# CITY OF ALBUQUERQUE

**Re: Martinez Retail/ PHASE 1**  
**1021 Old Coors Dr. SW**  
**Traffic Circulation Layout**  
Architect's Stamp 04-22-24 (L11D071)

TRAFFIC CIRCULATION  
LAYOUT APPROVED

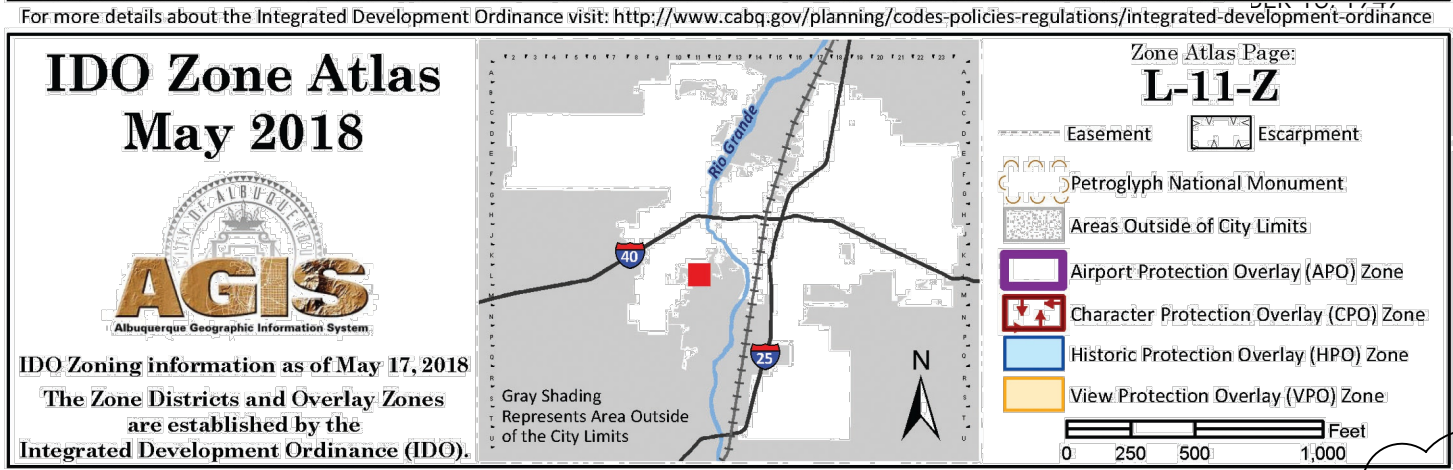
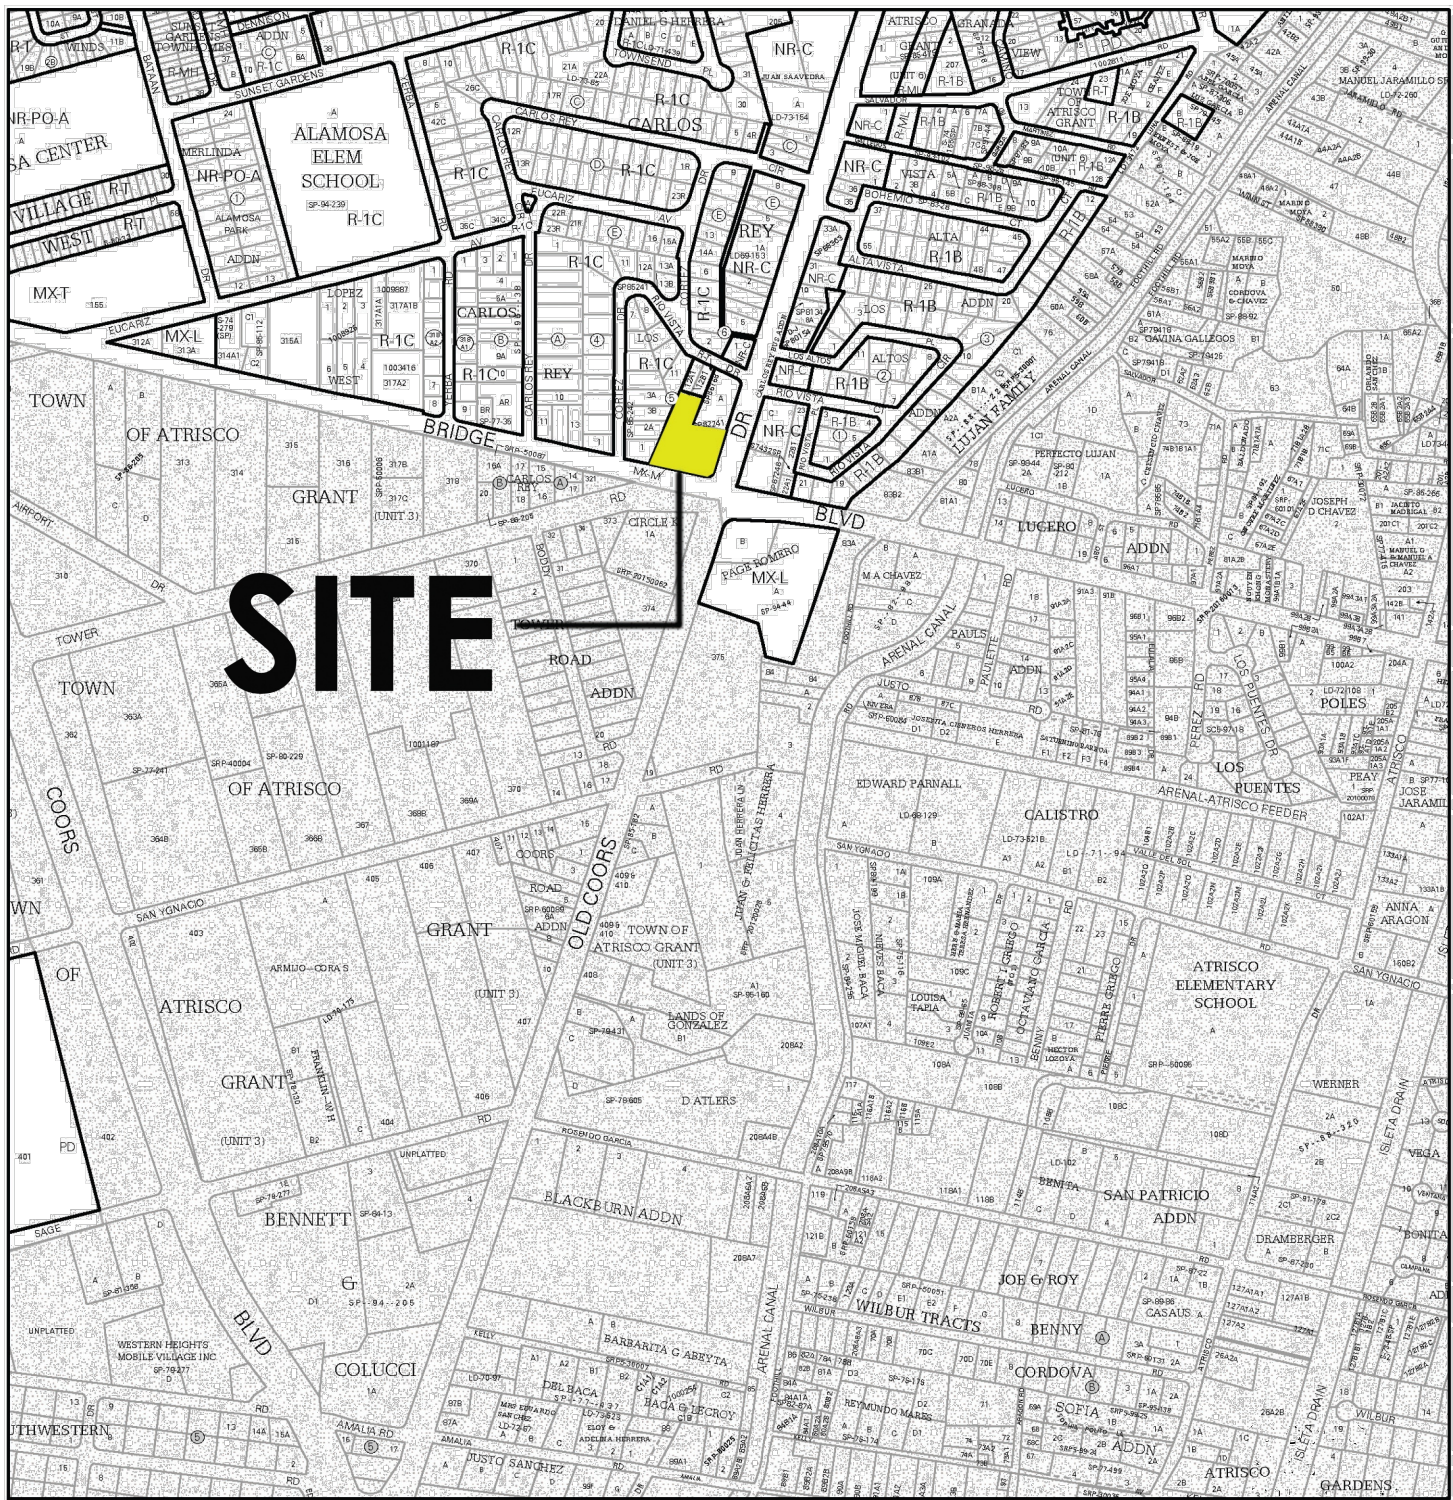
When the site construction is completed and an inspection for Certificate of Occupancy (C.O.) is requested, use the original City stamped approved TCL for certification. Redline any minor changes and adjustments that were made in the field. A NM registered architect or engineer must stamp, sign, and date the certification TCL along with indicating that the development was built in "substantial compliance" with the TCL. Submit this certification, the TCL, and a completed Drainage and Transportation Information Sheet to front counter personnel for log in and evaluation by Transportation. **1. AN APPROVED PLAT IS A CONDITION OF RELEASING THE FINAL CO FOR PHASE 1.**  
**2. EXISTING DRIVE ACCESS OFF BRIDGE BLVD MUST BE CLOSED AND REPLACE WITH NEW SIDEWALK PER CITY STD DWG 2430.**
